Item 6.**Development Application: 54-56 Riley Street and 1 Crown Lane, Darlinghurst****File No.:** D/2018/355**Summary****Date of Submission:** 12 April 2018 with amended plans submitted on 10 July and 11 October 2018**Applicant:** Milina Investments Pty Ltd & Scarlis Projects Pty Ltd**Architect/Designer:** Project Tourism International Architecture Pty Ltd**Developer:** Milina Investments Pty Ltd & Scarlis Projects Pty Ltd**Owner:** Milina Investments Pty Ltd & Scarlis Projects Pty Ltd**Cost of Works:** \$3,900,794**Zoning:** The site is within the B4 Mixed Use zone and the proposed mixed use development is permissible with consent.**Proposal Summary:** The development application seeks partial demolition of the warehouse building at 1 Crown Lane and demolition of all other structures on the site; construction of a mixed use development on the site, comprising ground floor retail, 16 residential apartments over five levels, a commercial office suite, rooftop landscaping and communal open space, and servicing facilities.

Summary Recommendation: The development application is recommended for deferred commencement approval.

Figure 14: Ground floor plan, the shaded blue areas are above the required flood level for the use. The red line indicates where mezzanine is to be increased to.

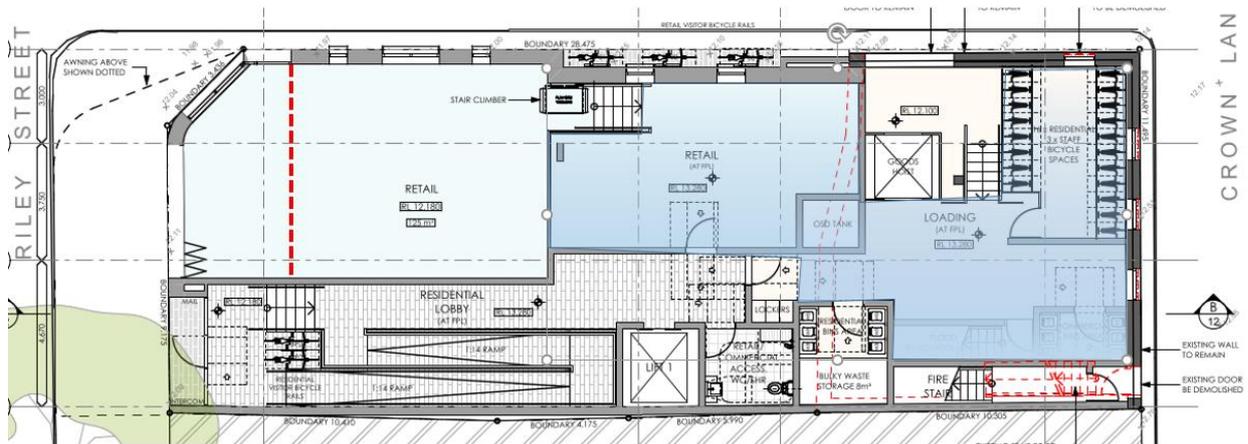
54. Notwithstanding this, it is considered that the area to be flooded is too large, due to the high hazard area. Therefore deferred commencement consent is recommended, requiring that the mezzanine area be increased and is to be setback 4m from the Riley Street boundary. This setback will allow some tables to be located at street level, if a café is proposed. A door is to be provided into the residential lobby to enable accessible entry.

58. The areas of the ground floor, which remain in potential flood areas are demonstrated in Figure 14 below. The areas identified in blue are above the required flood level for the use. The areas that will be subject to flood are the residential lobby entrance, the pedestrian loading area and a portion of the retail.
